ADDENDUM # 1

CONTRA COSTA COMMUNITY COLLEGE
D-1215 Art Gallery Demolition
Diablo Valley College

Date: June 15, 2023

Reference Pre-Bid
RFI #10

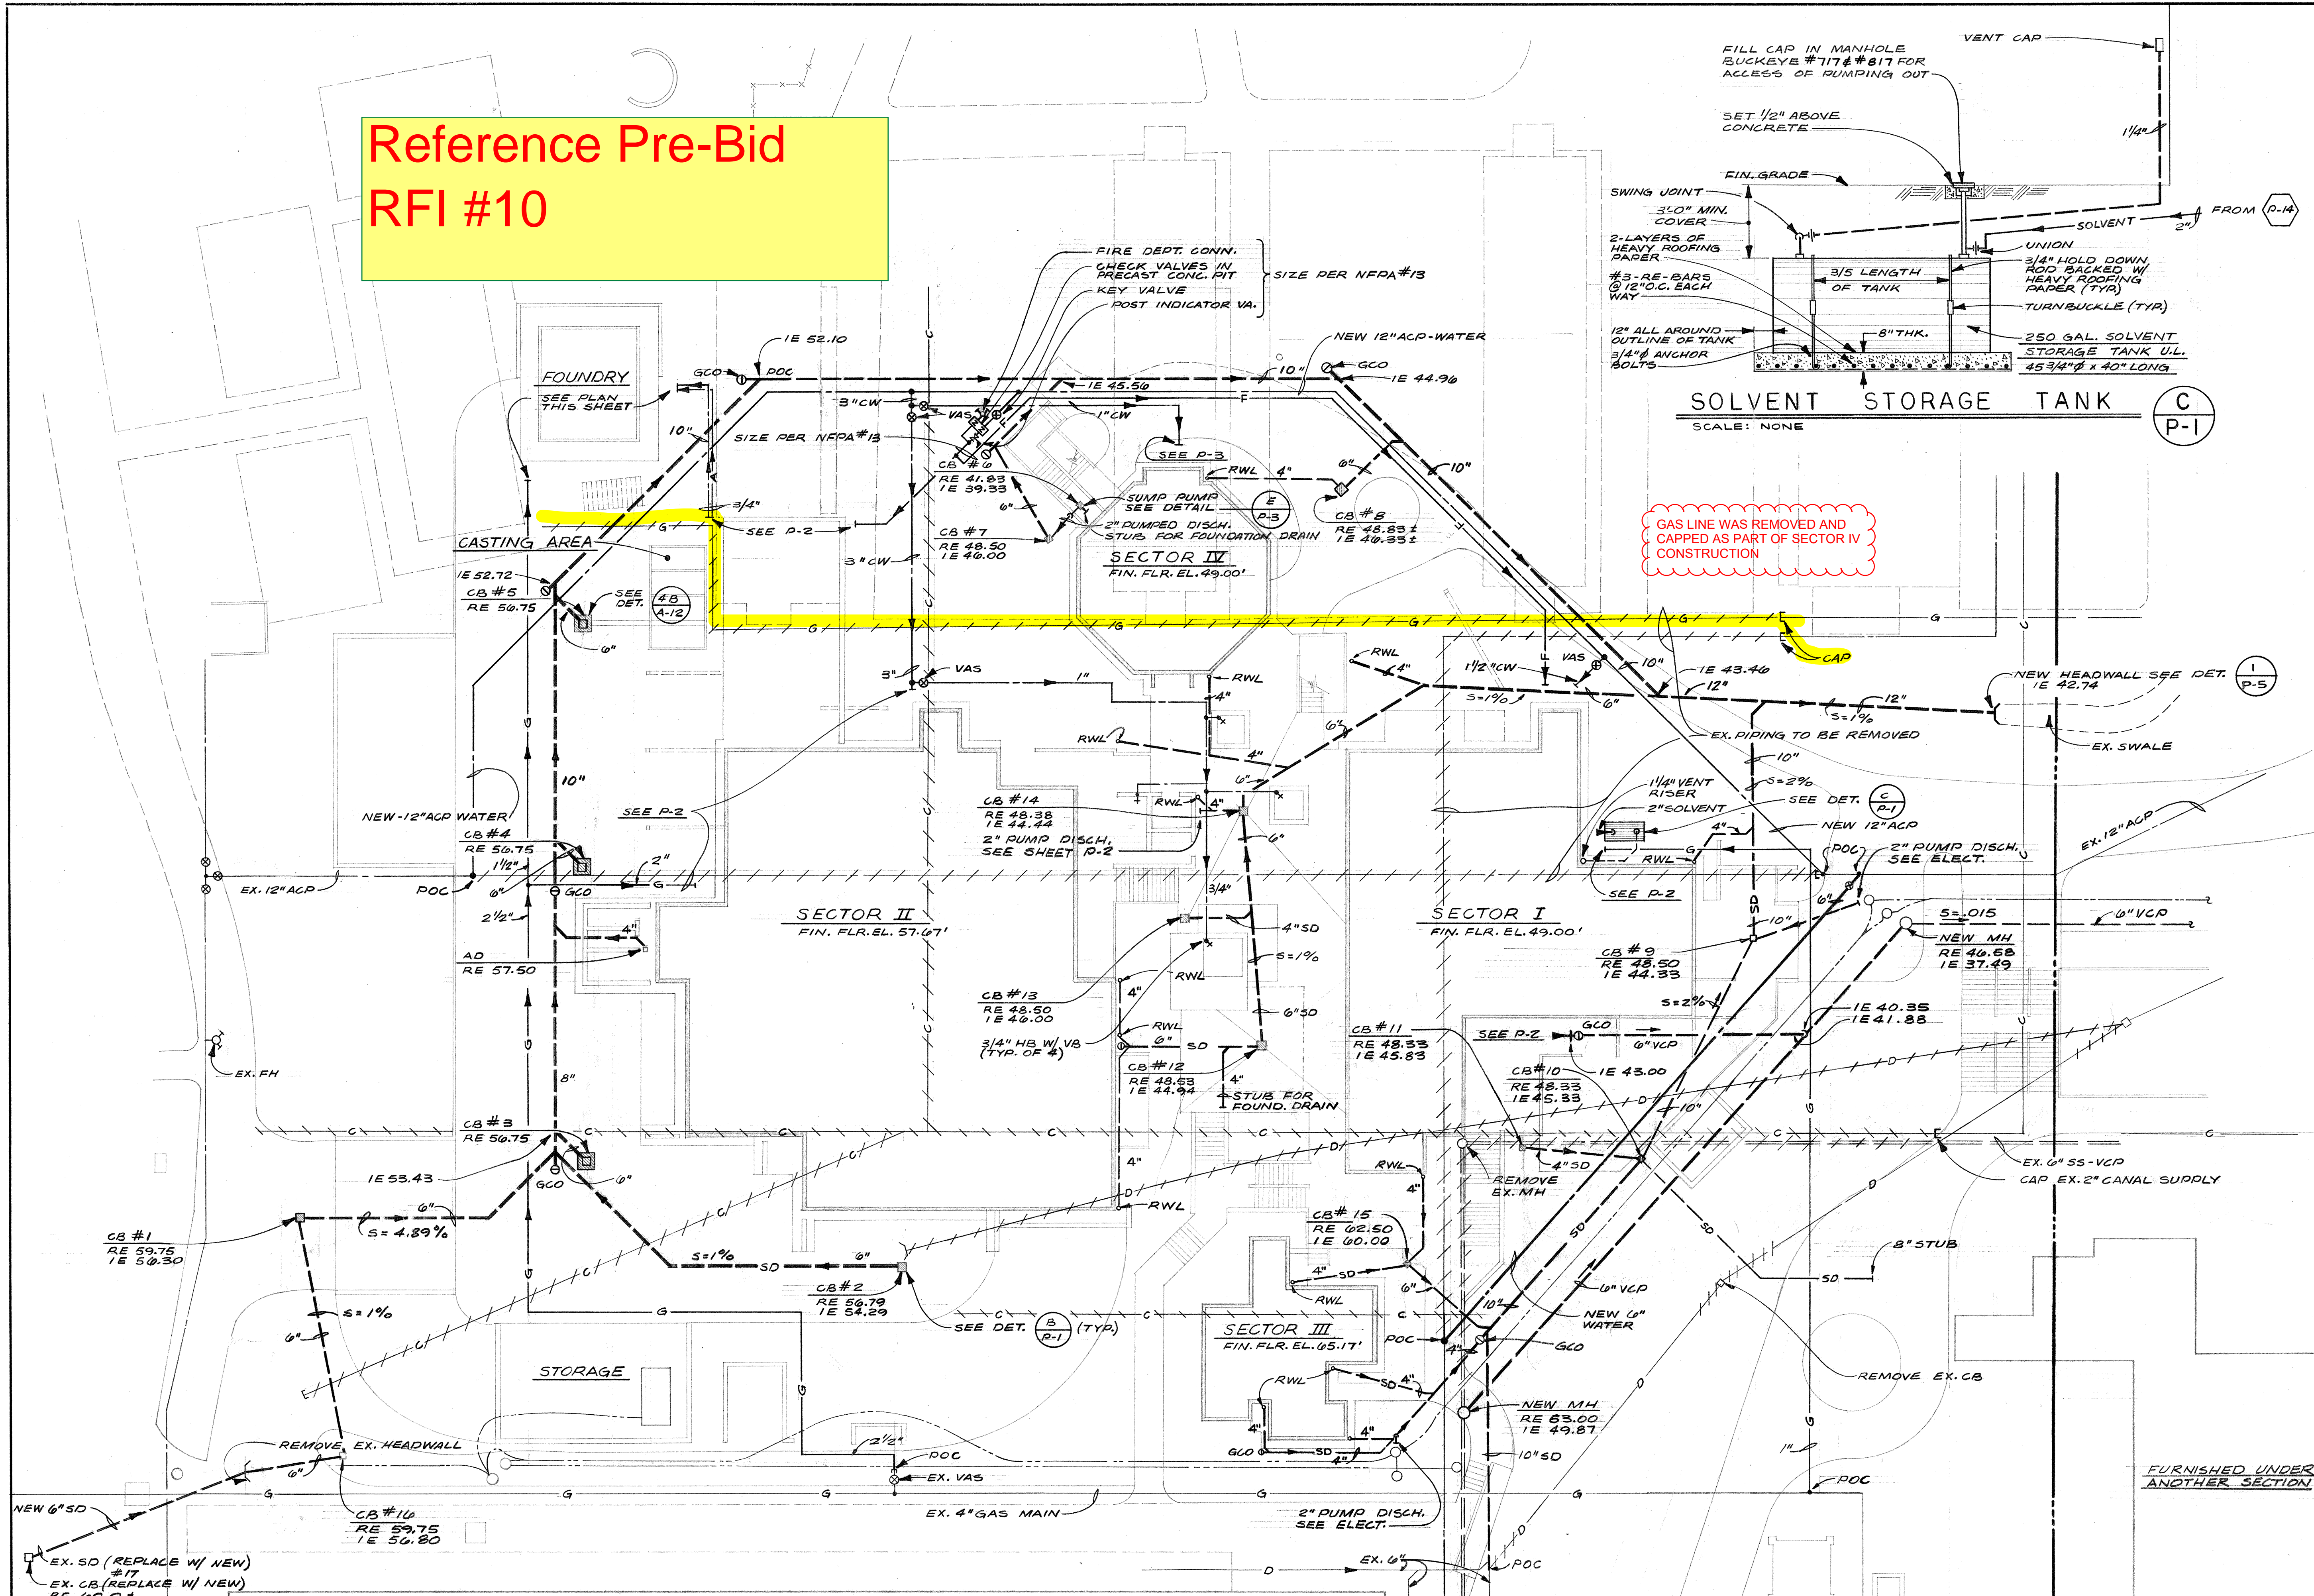
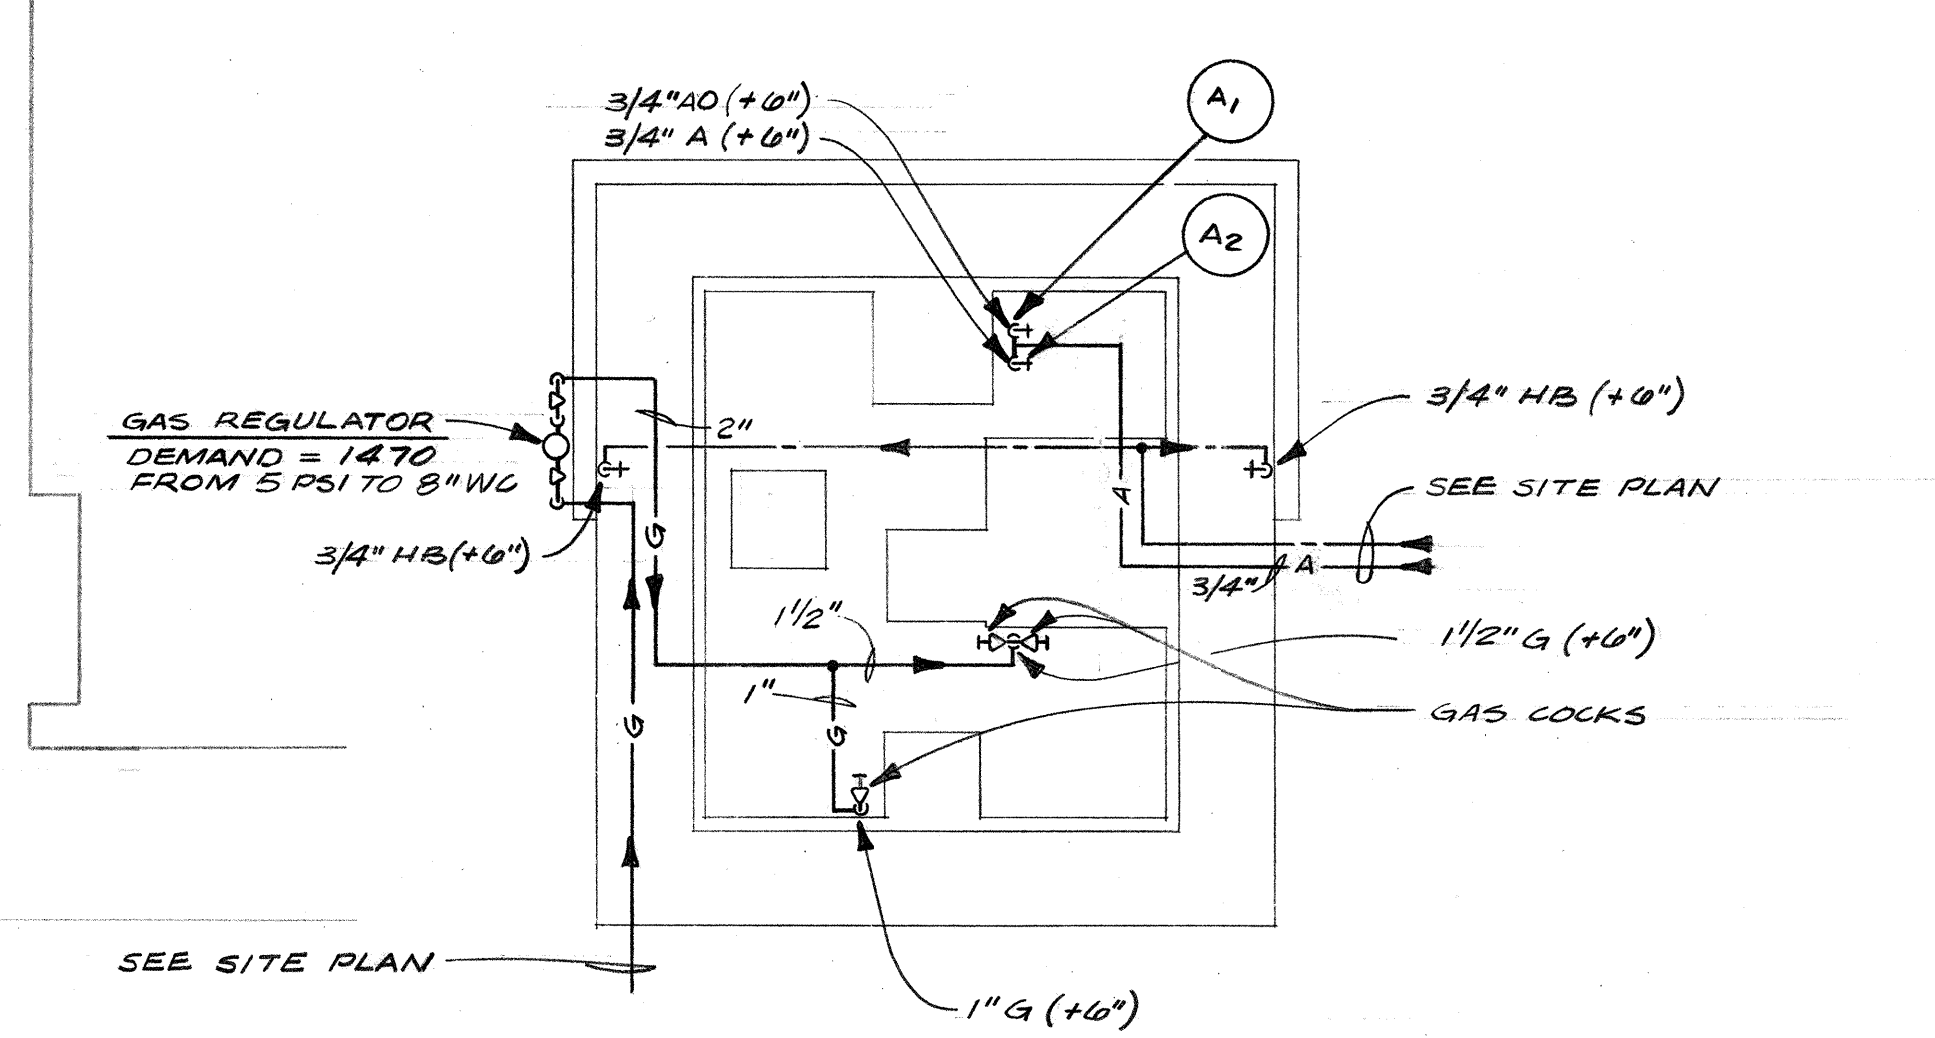
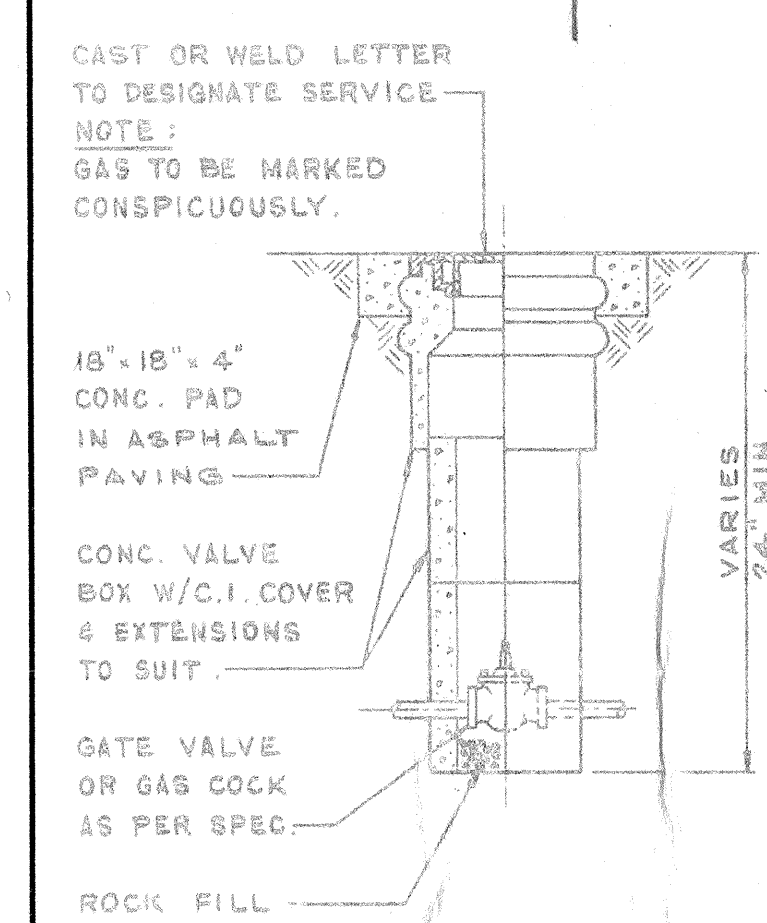
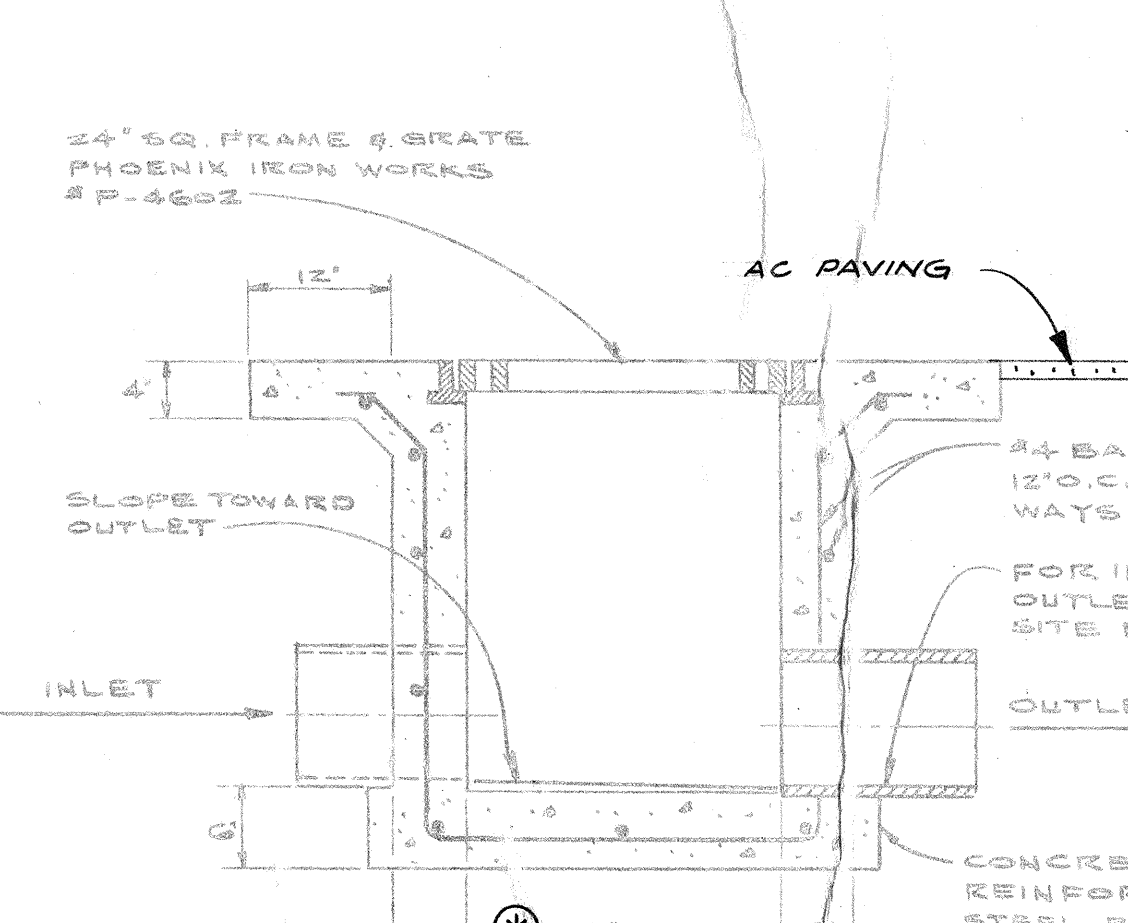
10	Contract Drawing Number DM001. An existing gas line is noted below grade to remain and be protected. Does this gas line also run below the Art Building structural foundation footprint. Please confirm or advise. If the gas line runs above the Art Building structural foundation, then per section 02 41 16 paragraph 3.3.A, will the gas line be temporarily shut off when requested by the contractor. Please confirm.	The gas line does not show to be running under the Art Gallery Building. TT confirms and agrees with Kitchell's comment. The existing drawings show an existing gas line that was either removed or abandoned. Please see attached drawing and DVC As-built drawing.
11	Project Specification Section 00 41 00 Bid Proposal Form paragraph 1.D. references the requirement to submit a fully executed Statement of Bidder’s Qualifications. Will a Contra Costa Community College District Contractor’s Qualification form detailing the required information be provided or will a bidder’s Statement of Qualification Form be acceptable? Please advise.	Per 4CD, this requirement is removed. See revised Spec Section 00 41 00.
